# *City of Brisbane*

## *Planning Commission Agenda Report*

**SUBJECT:** **Sign Program Modification SR-1-20 (Amendment to SR-7-19);** Sign Program Modification to “The Shore at Sierra Point Sign Program” for the HealthPeak Biotechnology Research and Development Campus; 800 to 1800 Sierra Point Parkway; Kevin Norman, DES Architects + Engineers, Inc., applicant; Scott Bohn, HealthPeak Properties, owner

**Sierra Point, Brisbane, CA.**  
Signage Master Plan

**R&D BUILDING WALL SIGNAGE: POTENTIAL SIGN LOCATIONS**

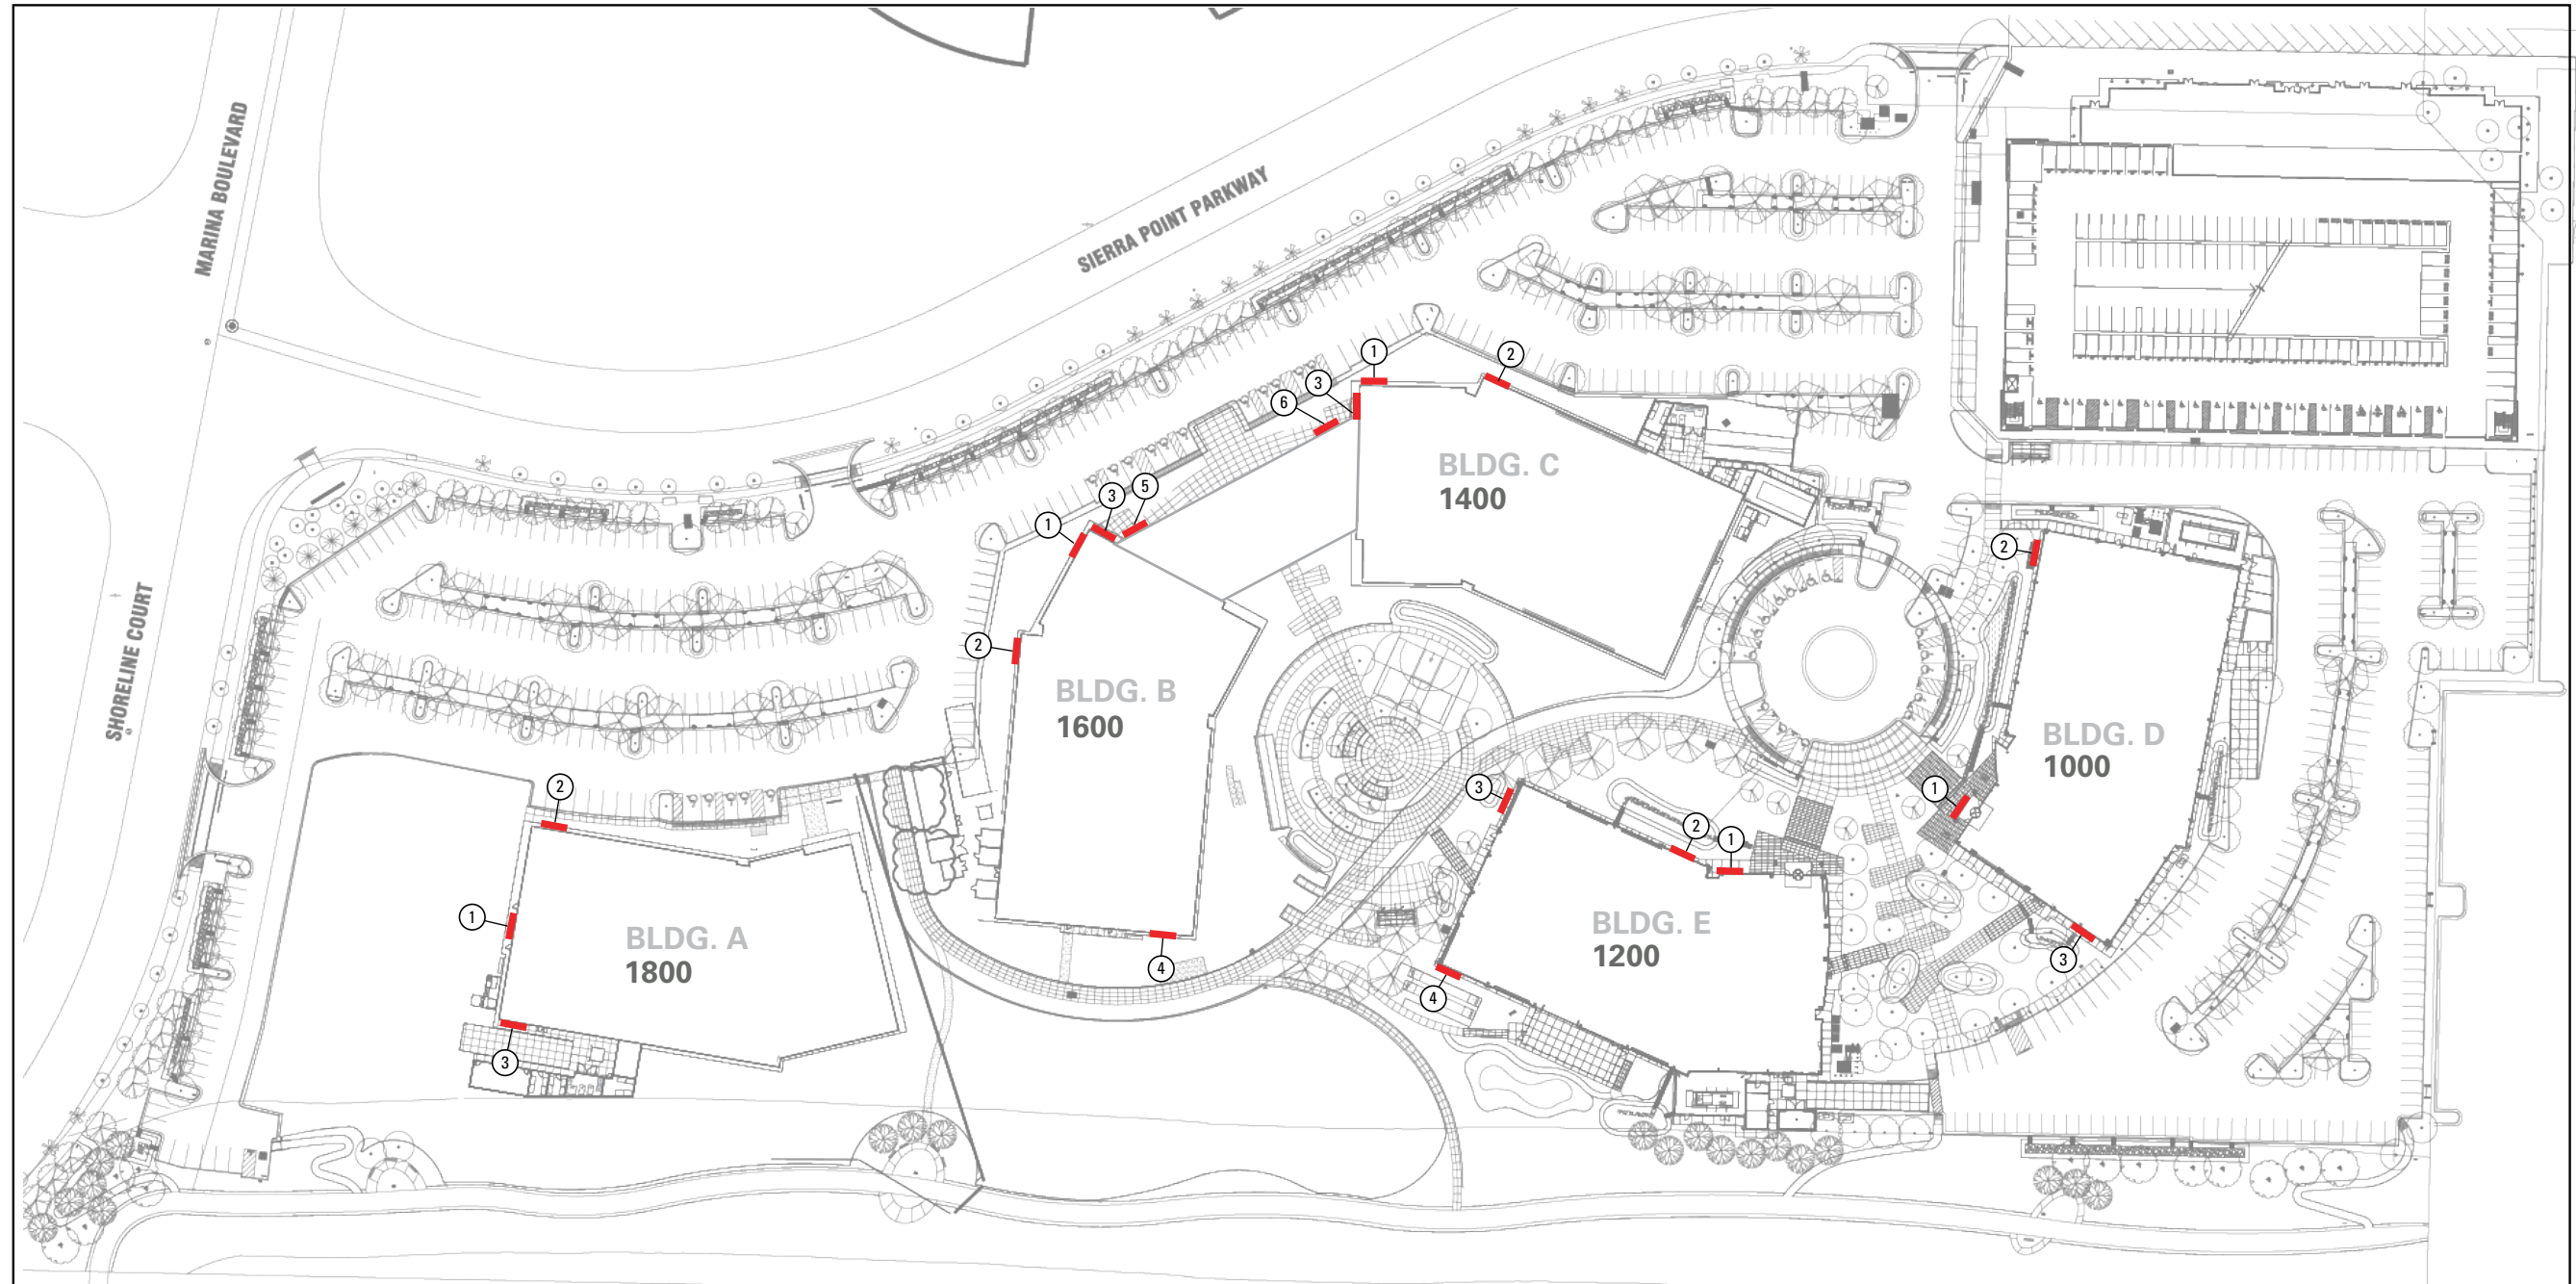
**Updated to Include Connector  
Bldg between 1400 and 1600  
Sierra Point Parkway - 7/22/21**

**R&D BUILDING WALL SIGNAGE: BLDG B ELEVATIONS**

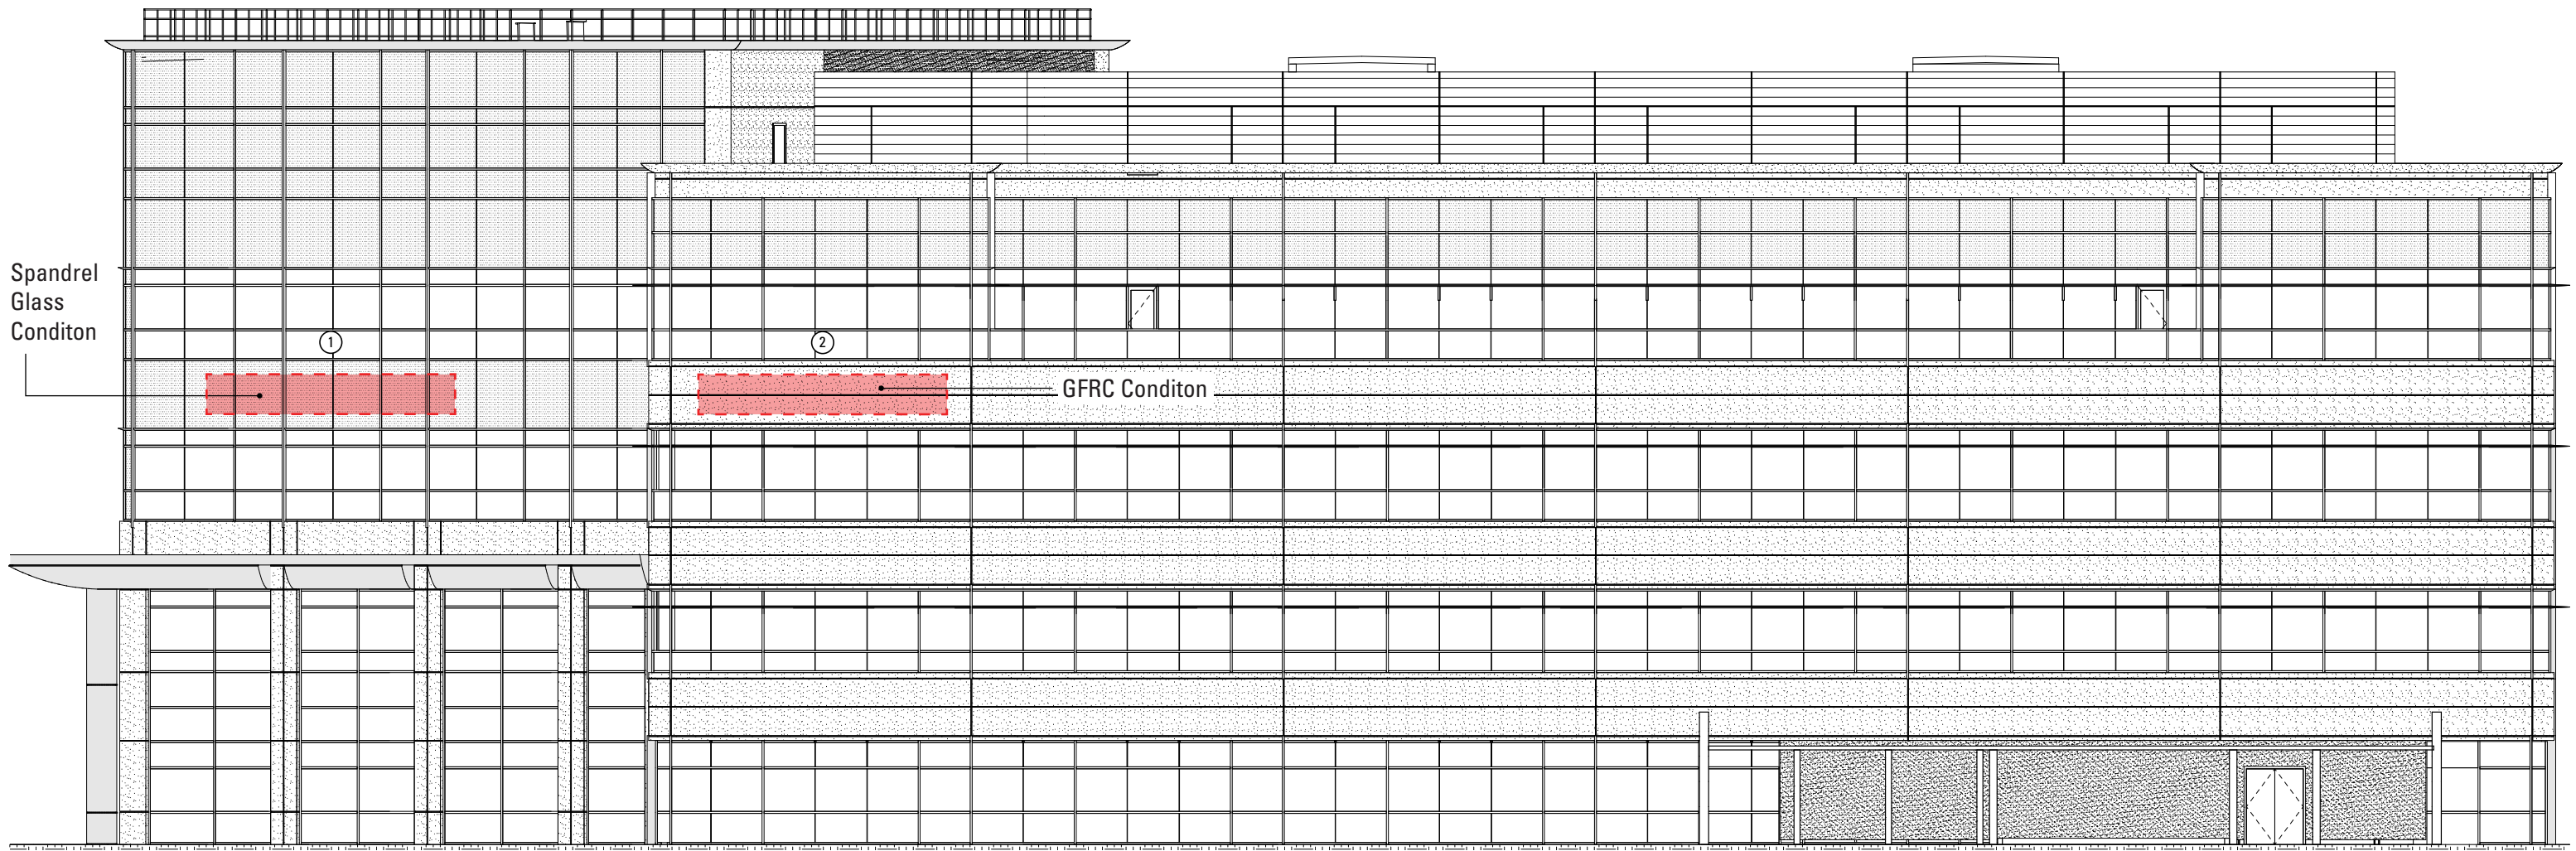
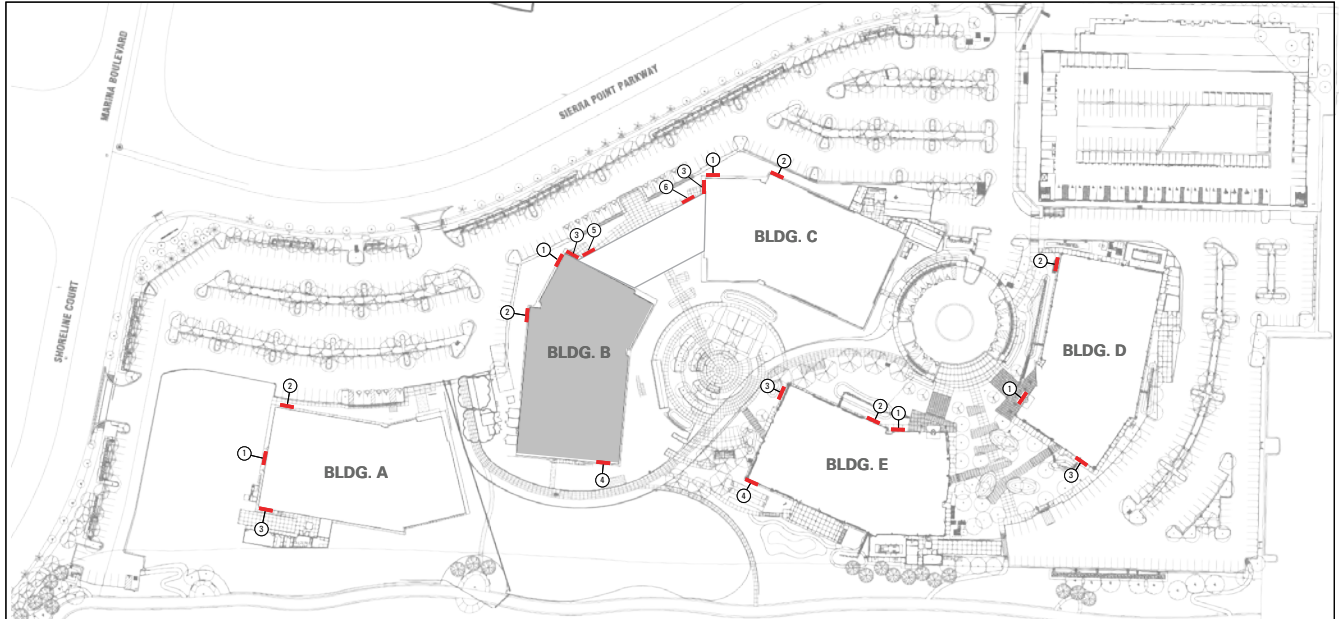
Updated to Include  
Connector Bldg between  
1400 and 1600 Sierra Point  
Parkway - 7/22/21

West Elevation: B1 & B2: 25' x 4', mounted to building facade

**R&D BUILDING WALL SIGNAGE: BLDG B ELEVATIONS**

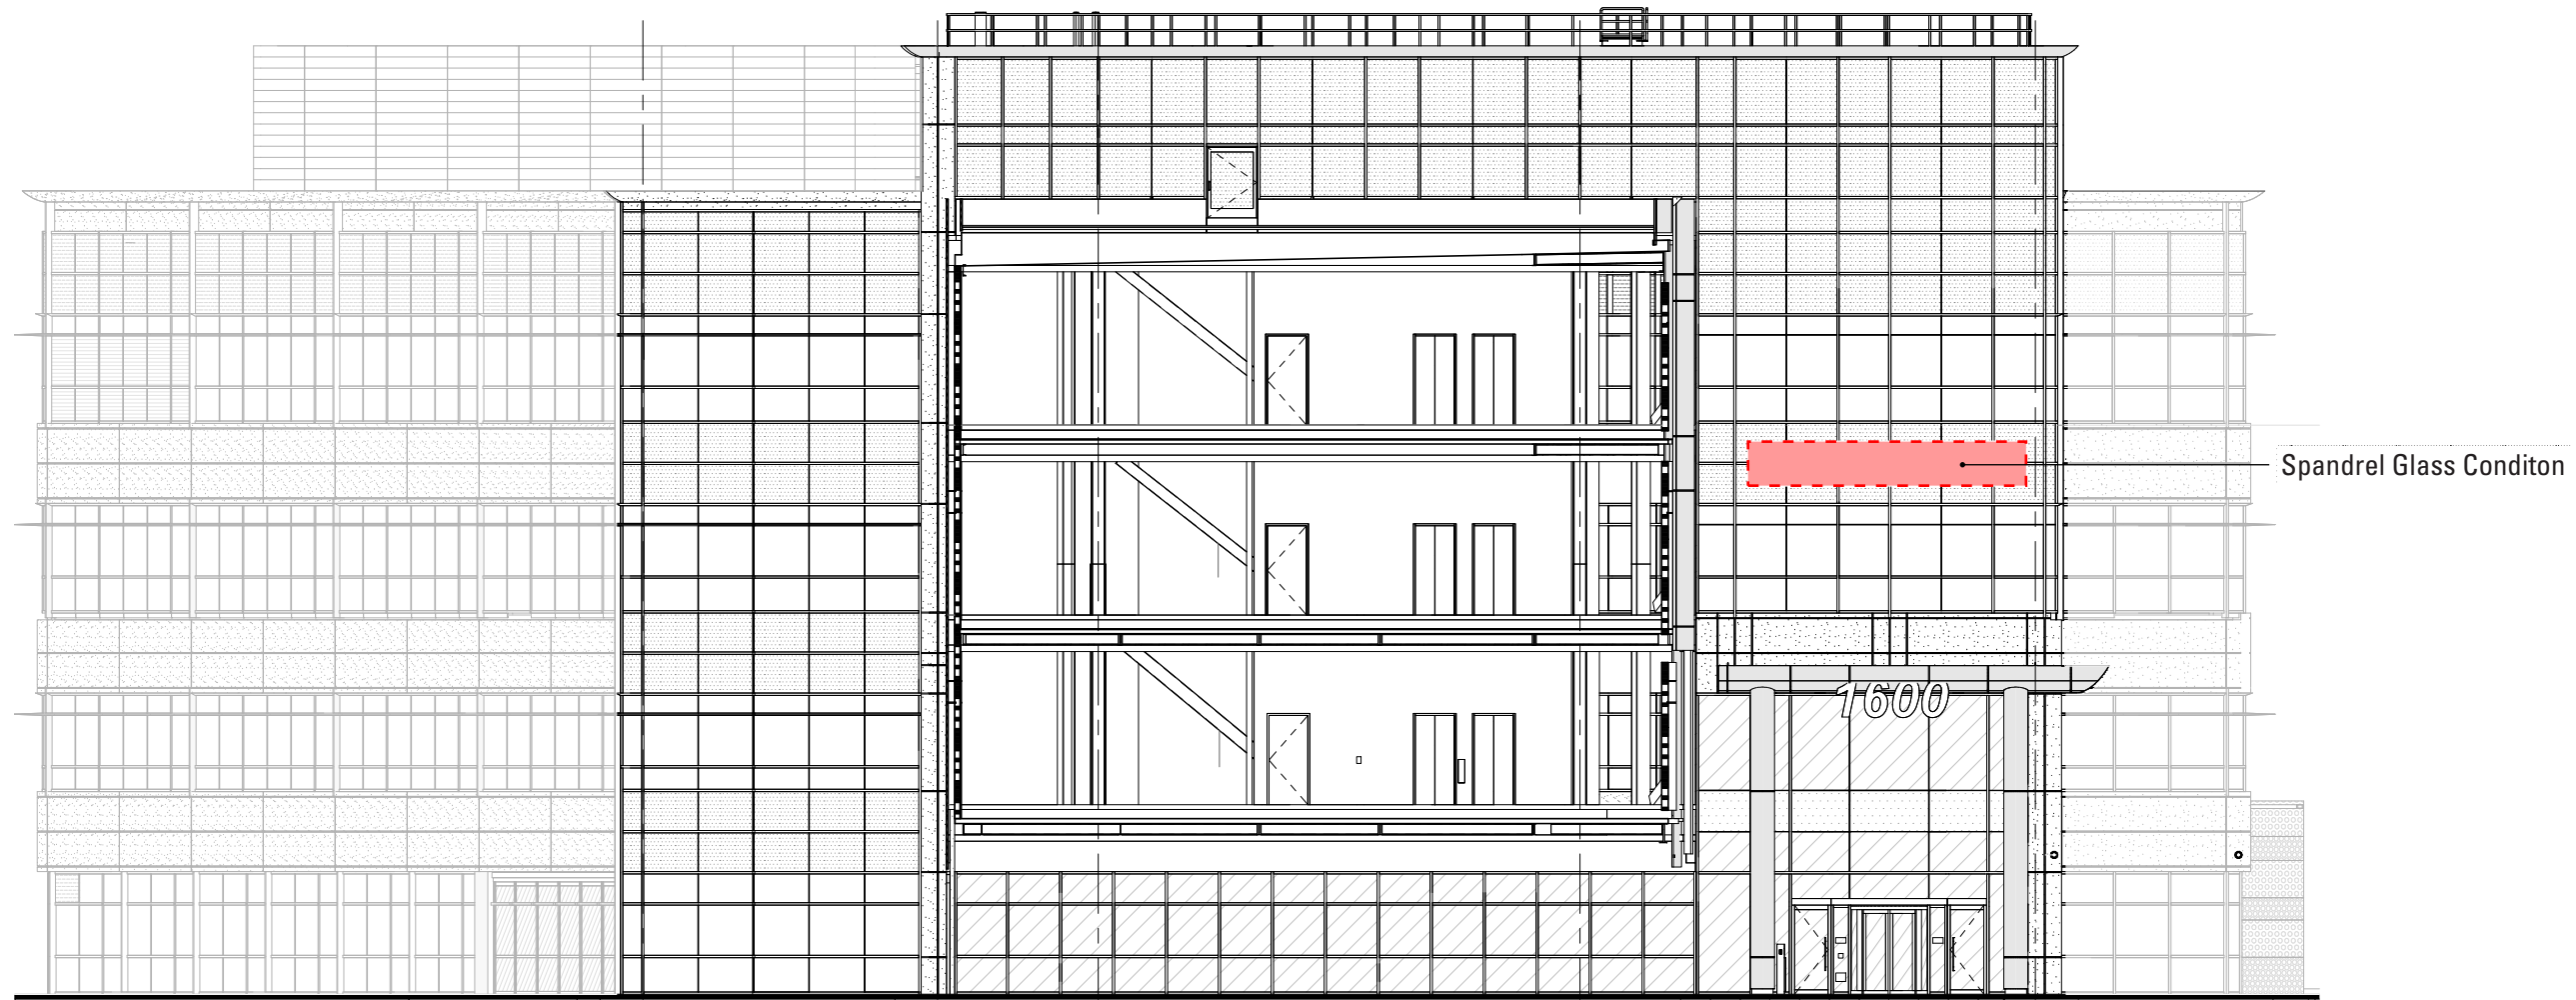
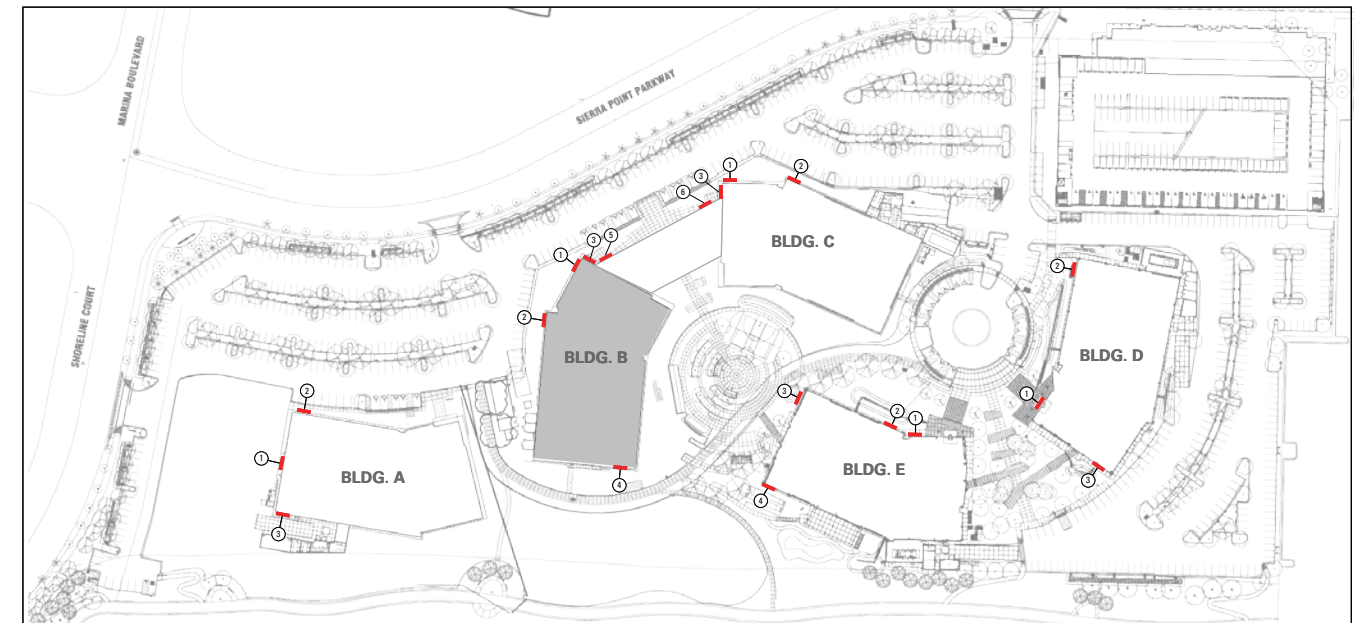
Updated to Include Connector  
Bldg between 1400 and 1600 Sierra  
Point Parkway - 7/22/21

North Elevation: B3: 25' x 4', mounted to building facade
